# 1966 Corvette: Service News: Wiring Diagrams for Breakerless Ignition Systems

**Subject:** Wiring Diagrams for Breakerless Ignition Systems

**Model and Year:** 1966 Passenger Cars

**Date:** November 1965 - Volume 37 - Number 10

Fig. 6—Breakerless Ignition System—Chevrolet, Chevelle & Chevy II

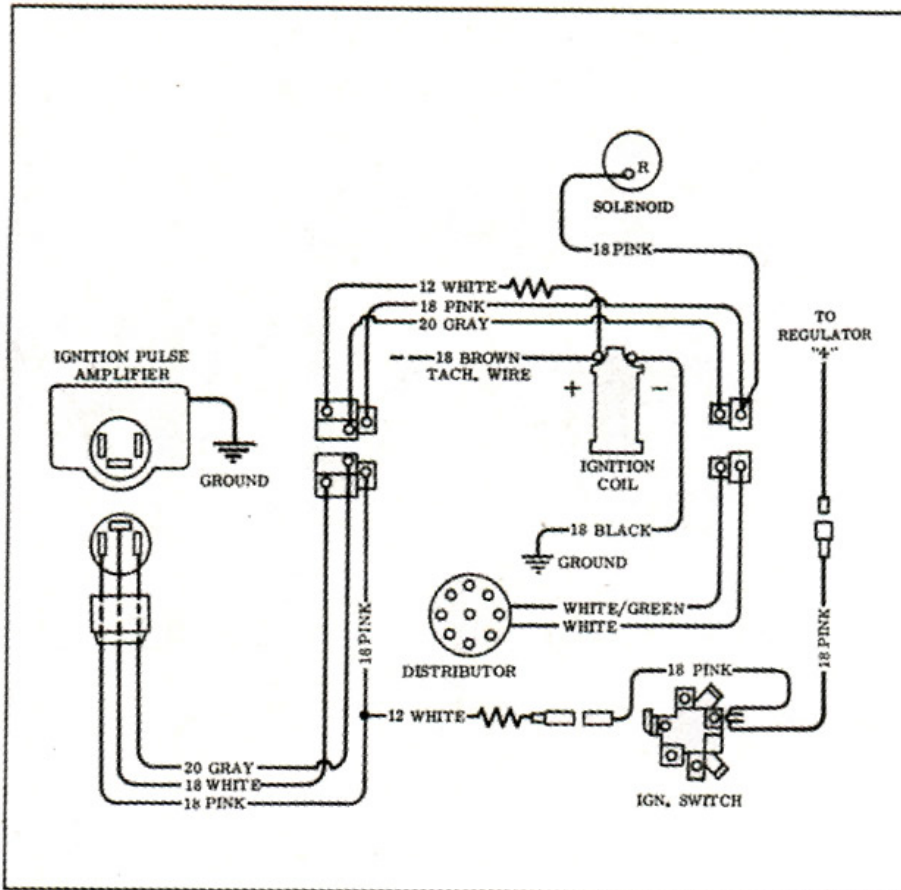
The following wiring diagrams for breakerless ignition systems superseded all other published diagrams for Chevrolet, Chevelle, Chevy II and Corvette.

The "12 white" is a calibrated resistance wire located on the negative side of the ignition coil on 1965 vehicles. However, in 1966 this resistance is placed on the positive side of the coil for added protection of the ignition pulse amplifier in case of accidentally grounding the ignition coil wire. At the present time, the above does not apply to trucks.
